8. Well Name and No.
Jicarilla 29-02-33 #33

Per the Notice of Intent dated 4-20-2015, to plug and abandon Jicarilla 29-02-33 #33, Black Hills Gas Resources is submitting the attached plug and abandon procedure.

PLUG AND ABANDONMENT PROCEDURE

CONDITIONS OF APPROVAL

Proposed P&A

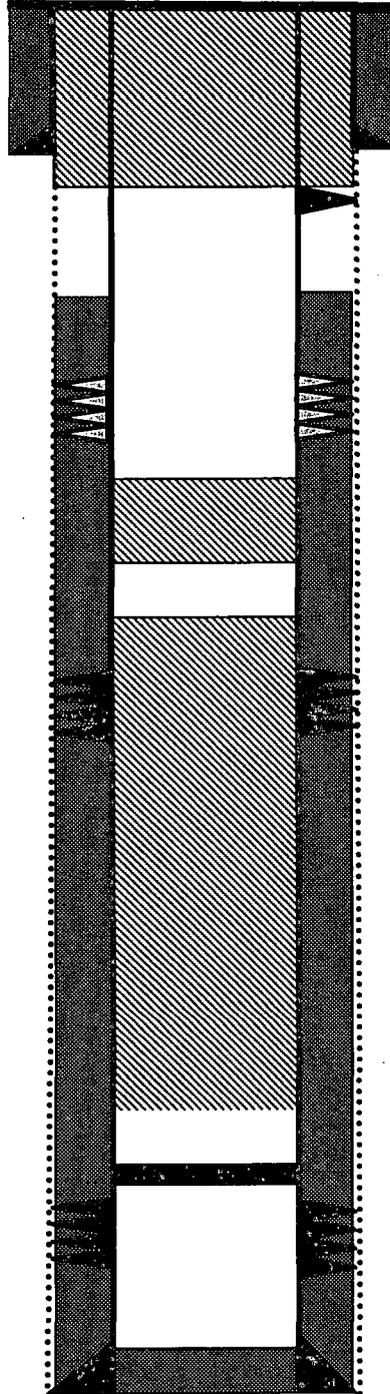
Plug #2: 2269' - 2169'
Class B cement, 17 sxs

1. Plugging operations authorized are subject to the attached "General Requirements for Permanent Abandonment of Wells on Federal and Indian Leases."
2. Farmington Office is to be notified at least 24 hours before the plugging operations commence (505) 564-7750.
3. The following modifications to your plugging program are to be made:
 - a) Bring the top of plug #2 to 2120 ft. to cover the Nacimiento top. Adjust cement volume accordingly.
